A G E N D A

Plat Staff Report

Case: SUB-59-2025

**PLAT
CLOPTON LAKE ESTATES
LOT 1, BLOCK A**

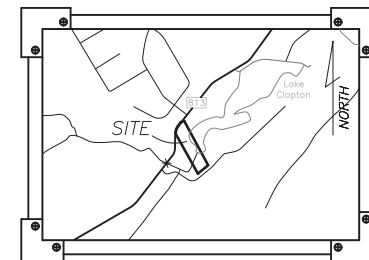
5. Per Section 2.4.c.4 of the Waxahachie Subdivision Ordinance, correctly show all easements. If there is an easement here, please provide the correct recording information for that easement. If this is not an easement, please remove water line label.

6. Per Section 2.4.c.4 of the Waxahachie Subdivision Ordinance, correctly show all easements. If there is an easement here, please provide the correct recording information for that easement.

7. Per Section 2.4.c.23 of the Waxahachie Subdivision Ordinance, a correct title block is required to be provided. Please provide the acreage for this location.

8. Per Section 2.4.c.23 of the Waxahachie Subdivision Ordinance, a correct title block is required to be provided. The correct case number for this plat is "SUB-59-2025."

9. Per Section 2.4.c.23 of the Waxahachie Subdivision Ordinance, a correct title block is required to be provided. Please ensure that you label that this is in the City of Waxahachie's ETJ.

10. Per Section 2.4.c.25.ii of the Waxahachie Subdivision Ordinance, please verify the correct bearing for this portion of the property line. This bearing does not match the legal description.

11. Per Section 2.4.c.25.vi.c of the Waxahachie Subdivision Ordinance, a correct Planning & Zoning Commission signature block for the City of Waxahachie is required. Please include an "Attest" with an accompanying "date" line for this signature block.

12. Per Section 2.4.c.25.vi.c of the Waxahachie Subdivision Ordinance, only the Planning and Zoning Commission Approval Block is needed due to the fact that the Planning and Zoning Commission is the approval body for this plat. Please remove the City Council and Mayor Approval Block.

13. Per Section 3.1.C.6 of the Waxahachie Subdivision Ordinance, the City of Waxahachie Thoroughfare Plan identifies this as 120' ROW. Please update the ROW Dedication to 20'.

14. Per Section 3.1.c.6 of the Waxahachie Subdivision Ordinance, please include the acreage of the ROW being dedicated by this plat.
15. Per Section 5.6 and 5.7 of the Waxahachie Subdivision Ordinance, fences, retaining walls, and screening walls shall not be placed in utility easements. Add this to the notes.

1. Per the Ellis County Subdivision and Development Standards, provide a completed Water Utility Endorsement Form
2. Per the Ellis County Subdivision and Development Standards, metes and bounds call N 16°42'41" E 159.86 does not match the plat drawing.

3. Per the Ellis County Subdivision and Development Standards, add computed gross acreage to the plat title block.
4. Per the Ellis County Subdivision and Development Standards, add "in the extraterritorial jurisdiction (ETJ) of the City of Waxahachie" to the plat title block.

5. Per the Ellis County Subdivision and Development Standards, update the front building line to 40'
6. Per the Ellis County Subdivision and Development Standards, add 5' ROW dedication along FM 813.

7. Per the Ellis County Subdivision and Development Standards, update the FEMA Floodplain Map info.
8. Per the Ellis County Subdivision and Development Standards, provide an original, embossed Tax Certificate demonstrating all property taxes are paid in full.
